UNITED STATES
DEPARTMENT OF THE INTERIOR
BUREAU OF LAND MANAGEMENTFORM APPROVED
OMB NO. 1004-0137
Expires: January 31, 2018**SUNDRY NOTICES AND REPORTS ON WELLS**
Do not use this form for proposals to drill or to re-enter an
abandoned well. Use form 3160-3 (APD) for such proposals.5. Lease Serial No.
NMNM92177

8. Well Name and No.
JRS HORZ FED 19. API Well No.
30-015-33066-00-S110. Field and Pool or Exploratory Area
BRUSHY DRAW-DELAWARE11. County or Parish, State
EDDY COUNTY, NM**SUBMIT IN TRIPLICATE - Other instructions on page 2**

REVISED P & A PROCEDURE

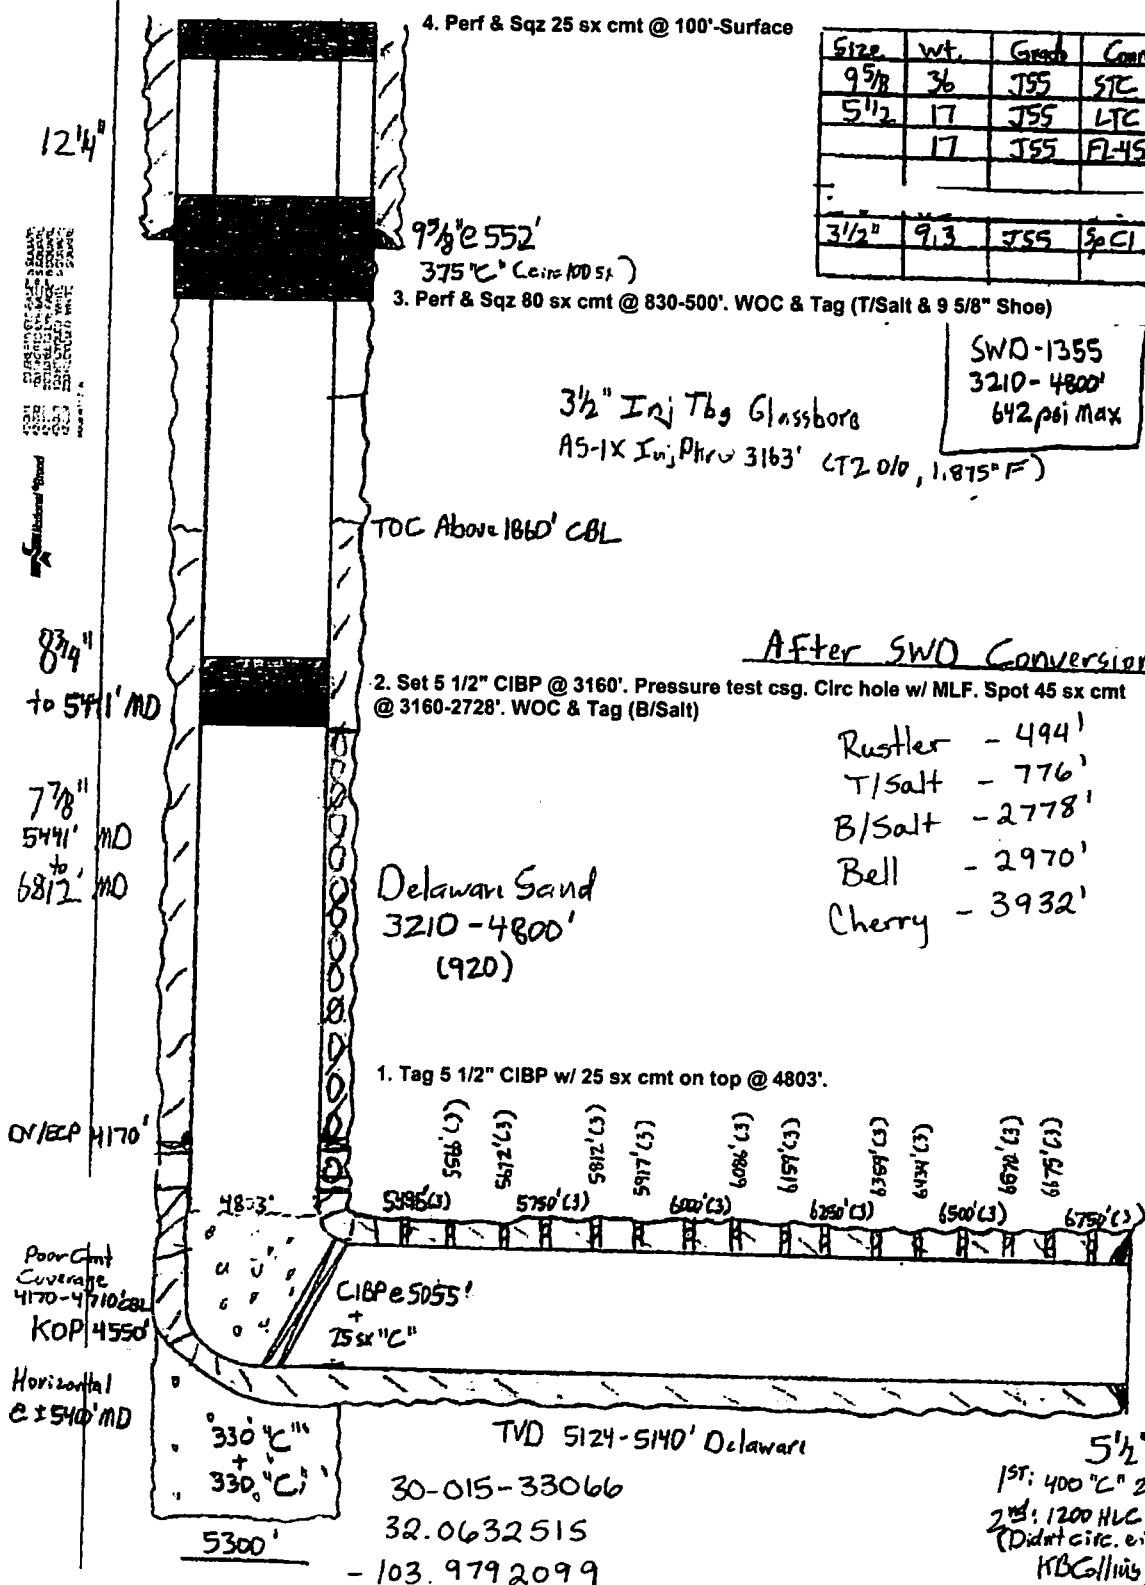
1. Tag CIBP W/ 25 sx cmt on top @ 4803'.
2. Set 5 1/2" CIBP @ 3160'. Pressure test csg. Circ hole w/ MLF. Spot 45 sx cmt @ 3160-2728'. WOC & Tag (B/Salt)
3. Perf at 2000 ft. Squeeze from 2000 ft to 1880 ft. WOC and TAG.
4. Perf & Sqz 80 sx cmt @ 830-500'. WOC & Tag (T/Salt & 9 5/8" Shoe)
5. Perf & Sqz 25 sx cmt @ 100'-Surface.
6. Cut off well head, verify cmt to surface, and weld on Dry Hole Marker.
